Point Beach Nuclear Plant, Units 1 and 2
Dockets 50-266 and 50-301
Renewed License Nos. DPR-24 and DPR-27

License Amendment Request 261, Supplement 4
Extended Power Uprate

LICENSE AMENDMENT REQUEST 261, SUPPLEMENT 4 EXTENDED POWER UPRATE

Case 9-1: 1B-32 MCC Voltage Profile

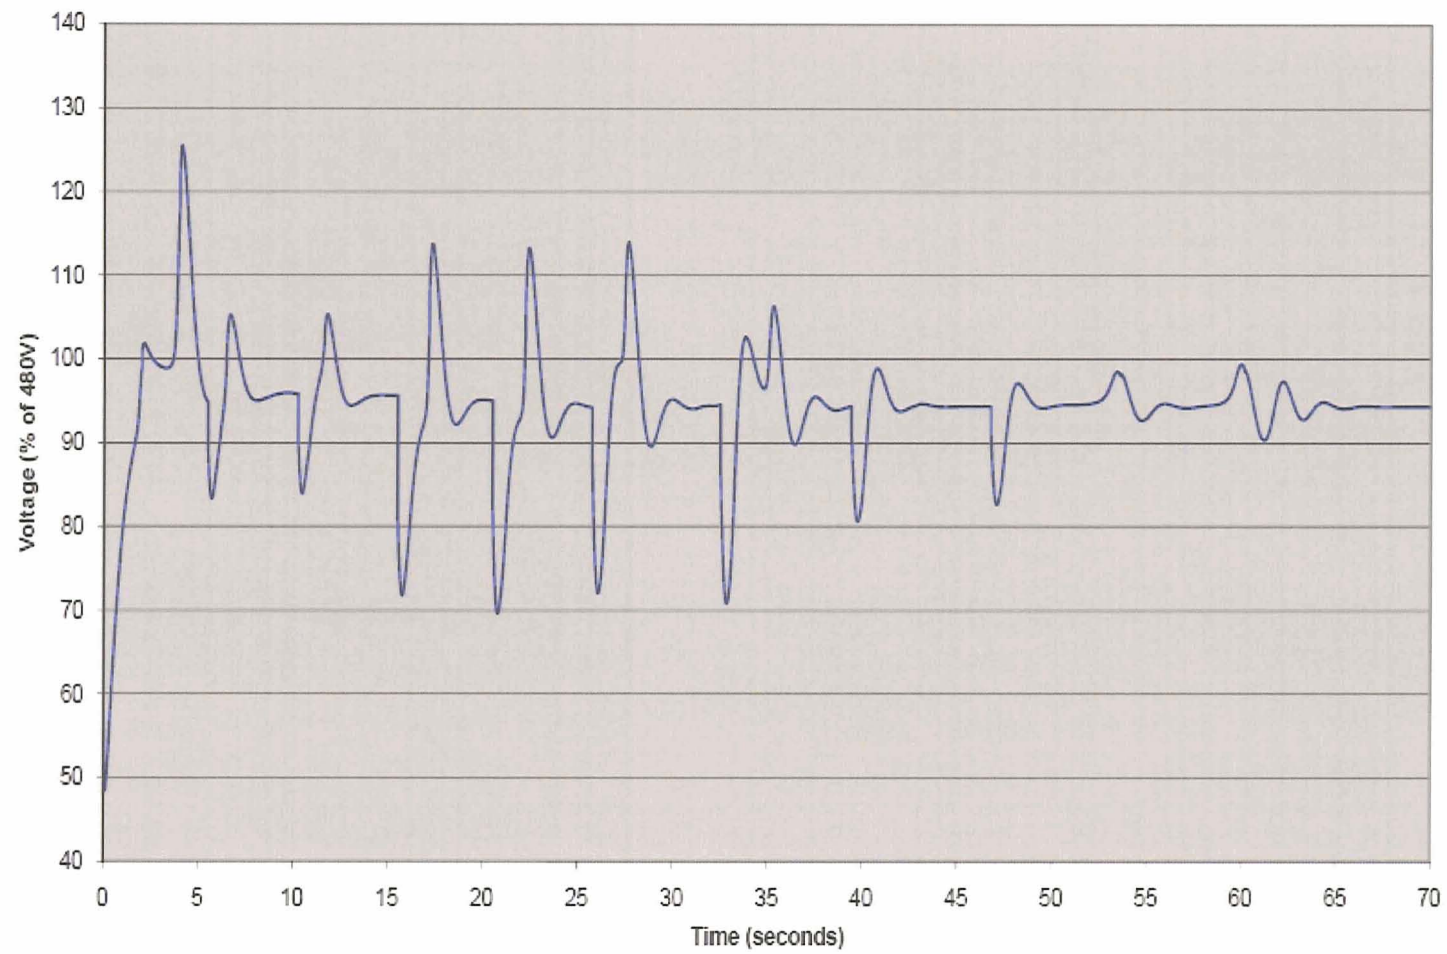
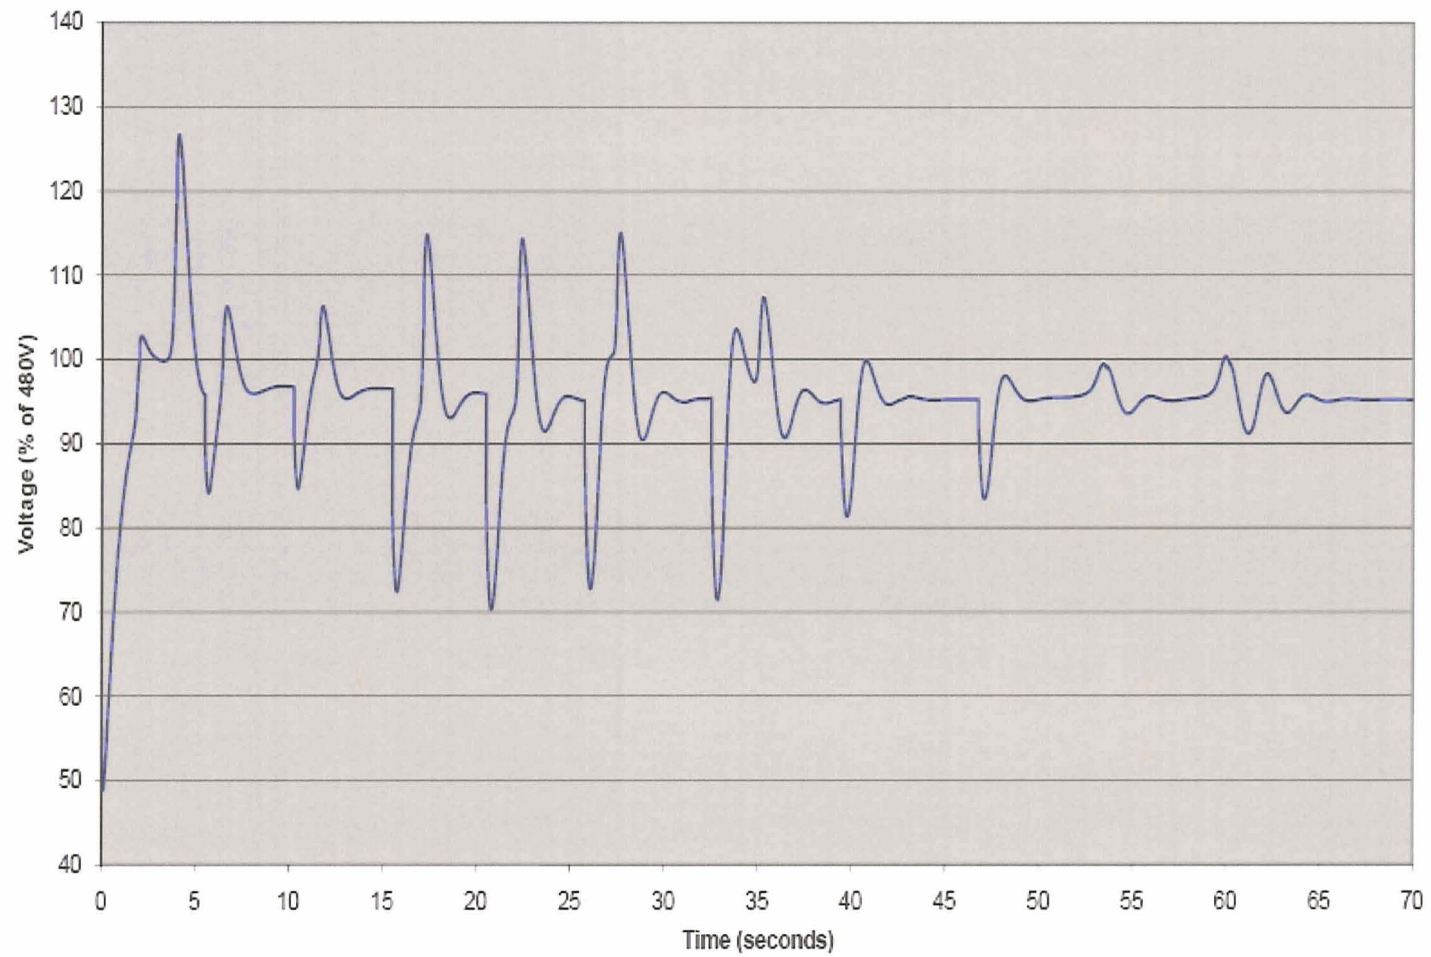
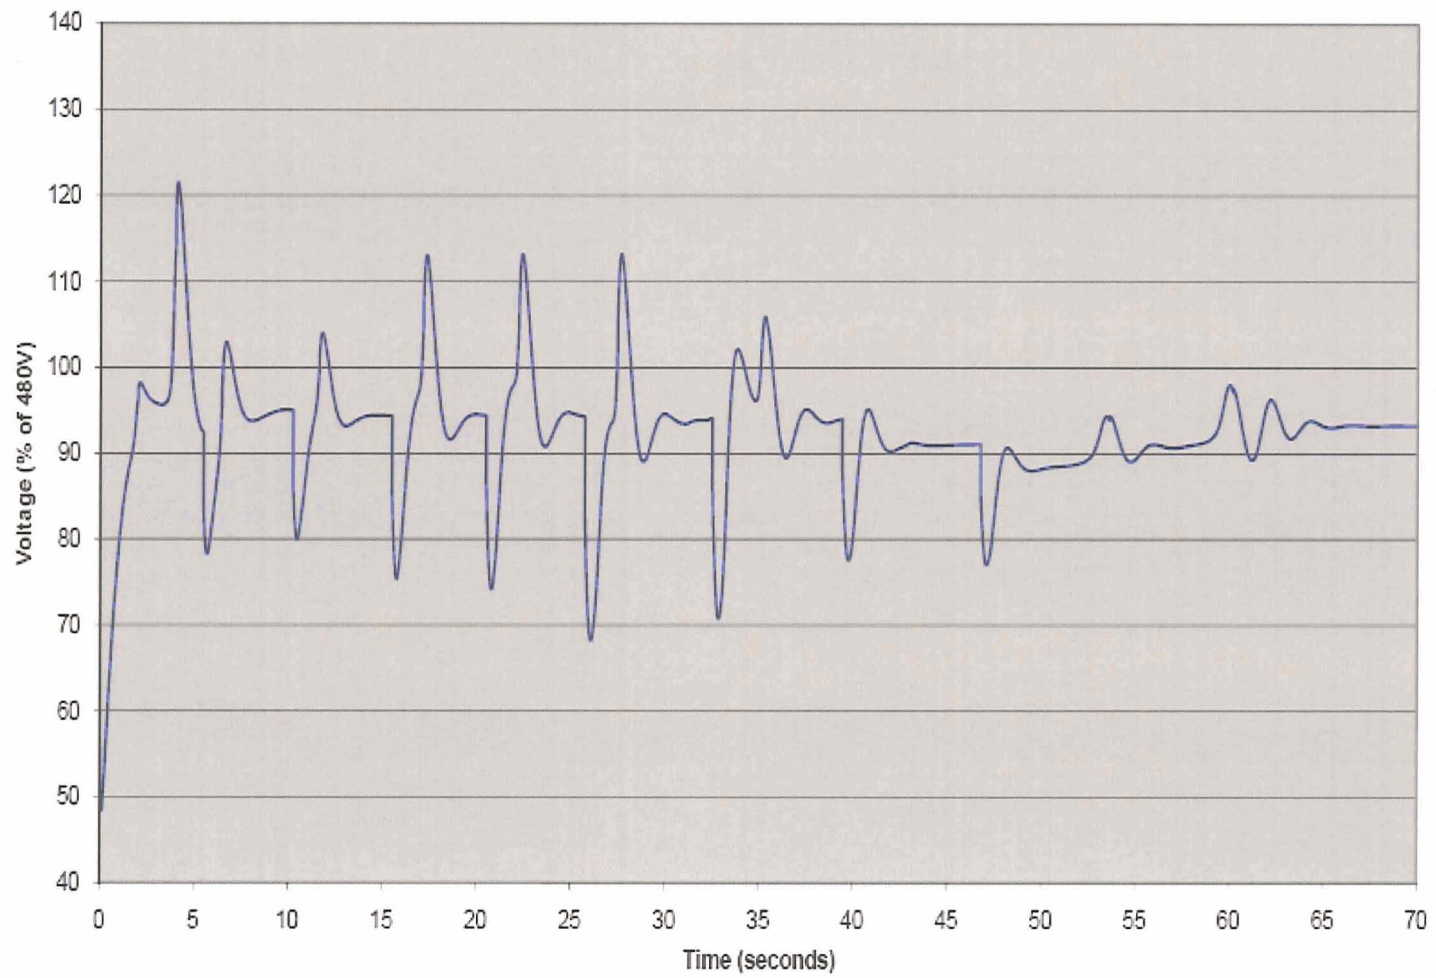
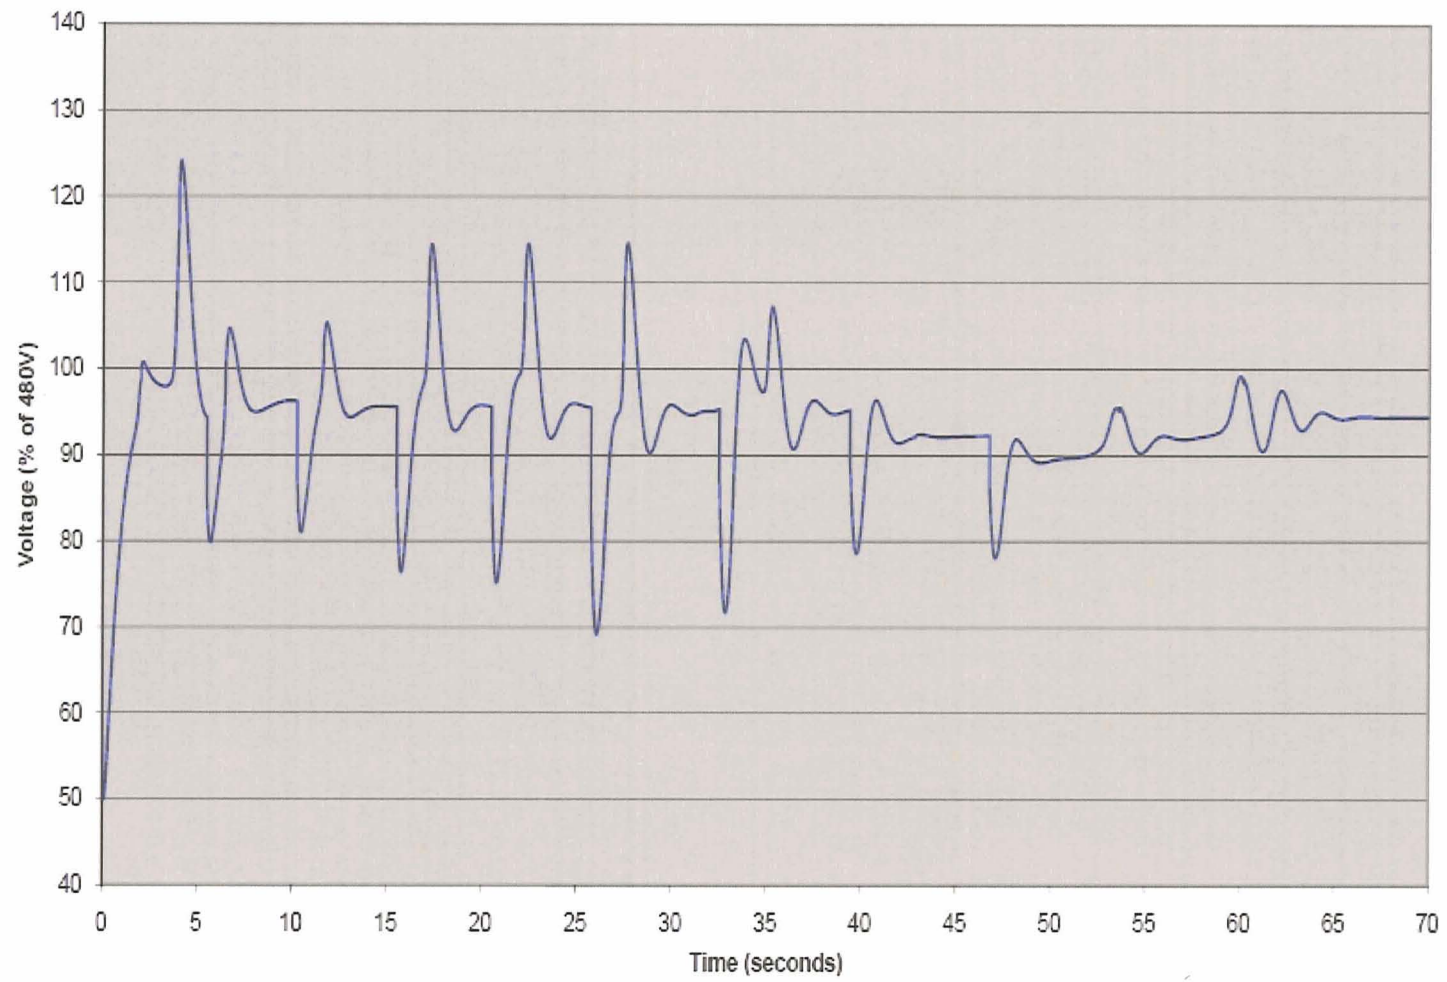
In response to staff's request for additional information (RAI) dated August 26, 2009, regarding the emergency diesel generator (EDG) voltage dip below the acceptance limit of 75 percent nominal voltage during motor start, the licensee stated that the EDGs are capable of starting safeguard loads, and the voltage recovers quickly to the acceptable level. Based on staff's review of the dynamic loading calculations, the staff notes that under certain loading conditions for Train "A" EDG, the frequency is outside 2 percent margin, the worst-case voltage dip is 45-48 percent and the voltage overshoot is 129.5 percent. Train "A" voltage and frequency variations are outside the industry accepted standards and guidance. Provide detailed analyses regarding the downstream effects on components such as contactors, control fuses, inverters, battery chargers, solenoids, motor-operated valves, solid state devices, etc., and the basis to show that all required loads will start and continue to run with sufficient margins after accounting for any uncertainties. Provide justification for the performance capabilities of the EDG "A" regulator and excitation systems to support shutdown equipment within design-basis requirements during a design-basis accident. The staff notes that Train "B" EDG bus voltages remain above 75 percent of nominal voltage, consistent with NRC Regulatory Guide (RG) 1.9, throughout the motor starting sequence in all postulated loading conditions. Provide a summary of all bus voltages for the 'B' train distribution system.

Attachment 3 provides a summary of bus voltages for the "B" train distribution system for the above large break LOCA design basis ETAP Cases.
